Daimler Buses Recall Bulletin

Orion V/VII Models
NHTSA 08V-480/TC 08-354

1.0 CABLE ROUTING RECALL NOTICE

SAFETY DEFECT: Alternator Cable Routing.

FIGURE 1-1 IMPROPERLY ROUTED CABLES IN CONTACT WITH FUEL LINES

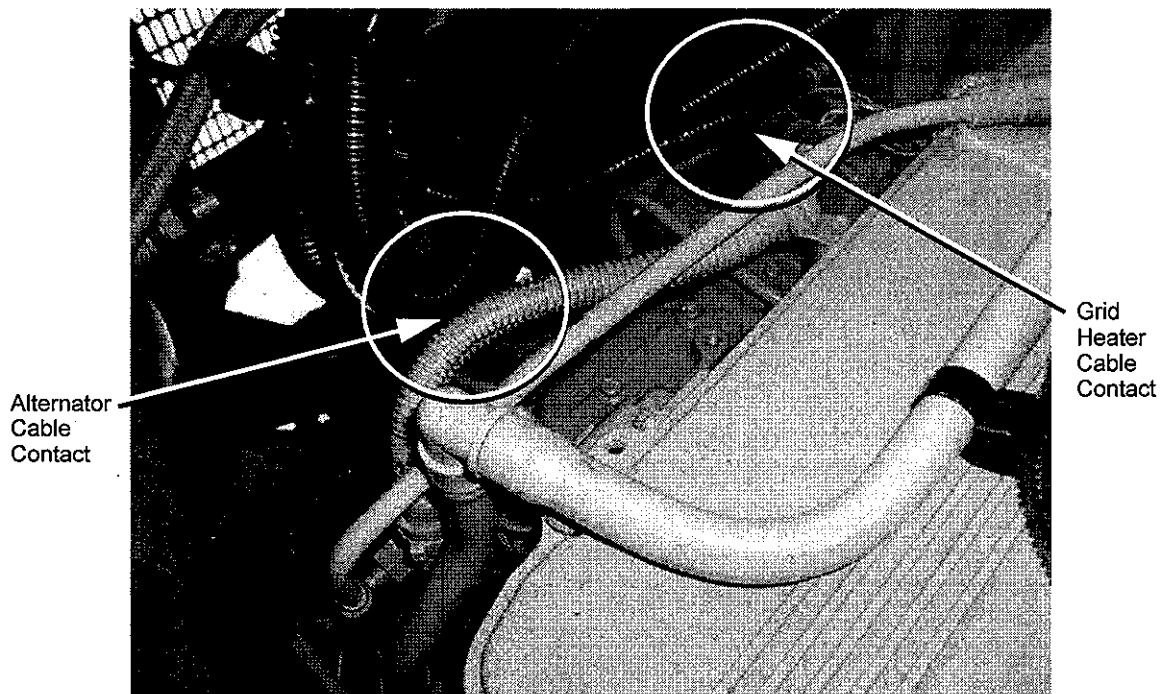
3. Inspect the alternator cable and grid heater cable for proper routing in the rear engine compartment to avoid the possibility of rubbing/chaffing against the #3 and #4 fuel injector lines. (See Figure 1-1.)
 - a. If the cables come in contact with the fuel injector lines as indicated in Figure 1-1 but no damage is found, reroute the cables following the procedure outlined in "Rerouting Improperly Routed Cables" on page 5.
 - b. If the cable loom or insulation is damaged on either cable, replace the cable(s) as indicated in "Alternator Cable Replacement" on page 6 or "Grid Heater Cable Replacement" on page 6.

FIGURE 1-2 CHAFFING DAMAGE TO FUEL INJECTOR LINE

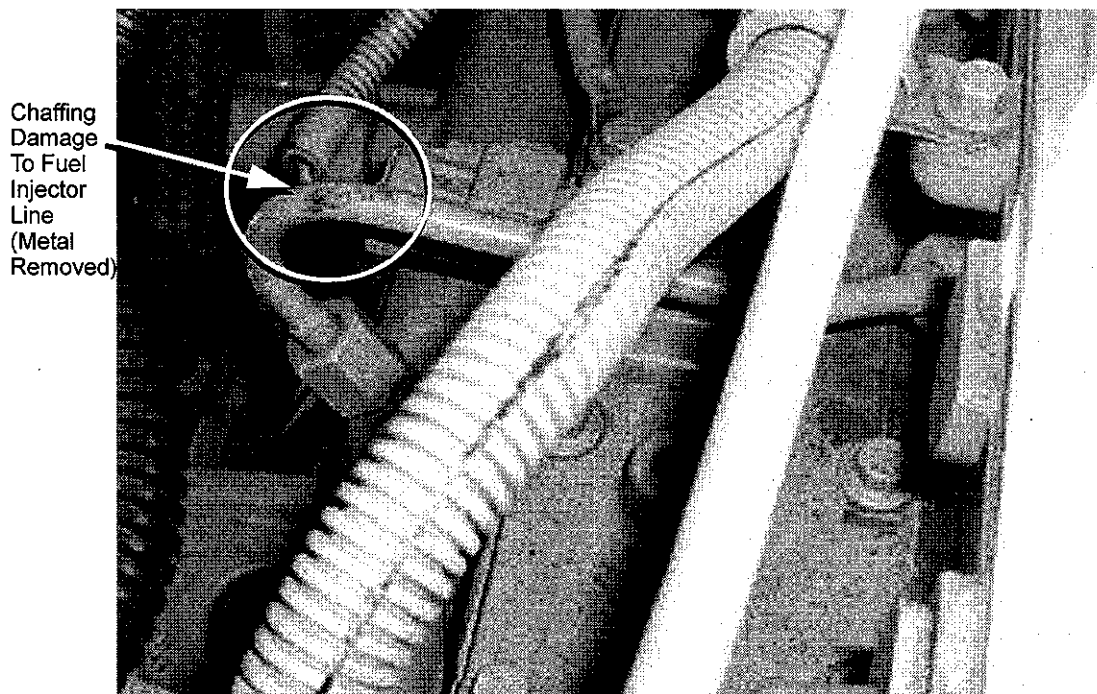
4. Inspect the #3 and #4 fuel injector lines for chaffing damage as shown in Figure 1-2. If any metal has been removed, replace the fuel injector line as indicated in "Fuel Injector Line Replacement" on page 6.

FIGURE 1-3 ALTERNATOR AND GRID HEATER CABLES WITH DUAL CLAMP TIE INSTALLED

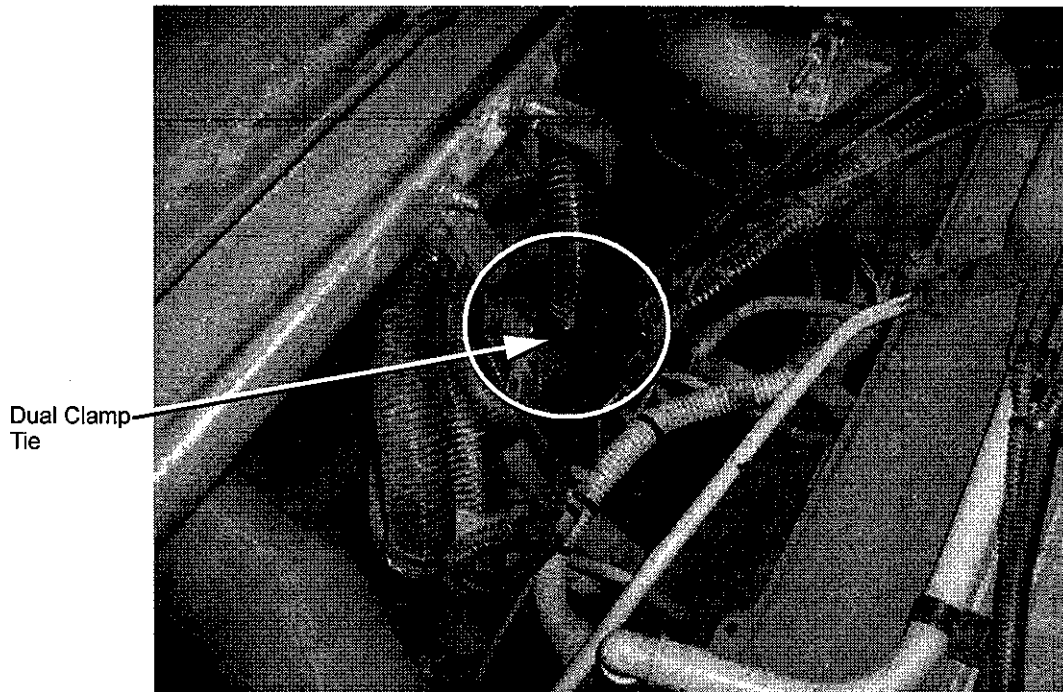
If the alternator cable and grid heater cable are making contact with the #3 and #4 fuel injector lines as indicated in **Figure 1-1** but no damage is found:

1. Loosen the p-clamp or clamps securing the alternator and grid heater cables in the rear engine compartment.
2. Lift the cables clear of the injector line(s) and secure with a Dual Clamp Tie (**ORION P/N 051048002**) as indicated in **Figure 1-3**.
3. Re-tighten any p-clamps loosened in **step 1**.
4. Close the interior access panel located under the rear center seat section inside the bus.
5. Return the battery isolator switch to the ON position.
